Re: Rapiscan AIT System Radiation Survey Reporting

Rapiscan systems	Secure 1000 Radiation Emission Measurement	FORM R-0646-1 (Single Pose)
----------------------------	---	--------------------------------

R-0646-1 Addendum (Documentation Errors)

Product Name	Secure 1000SP (Single Pose)
Serial Number	S51002009
Radiation Emission Measurement	Radiation Survey Dated: 06/05/2010
RSO Initials	[REDACTED]

Side View

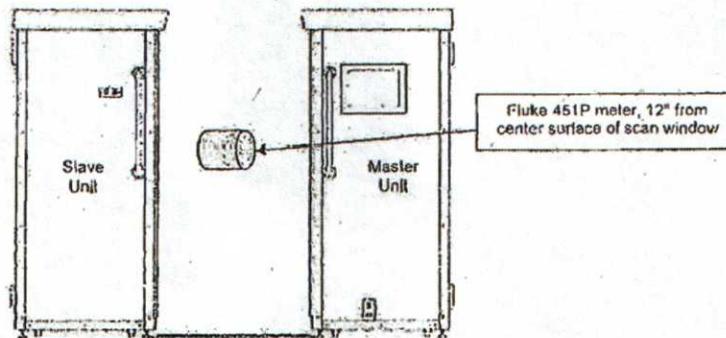
Technician indicated scan time as 7 seconds. Correct scan time is 3 seconds.

RSO will address issue with technician to ensure error is not repeated.

The corrected data indicates this system was operating within expected parameters. No re-survey is required for this system.
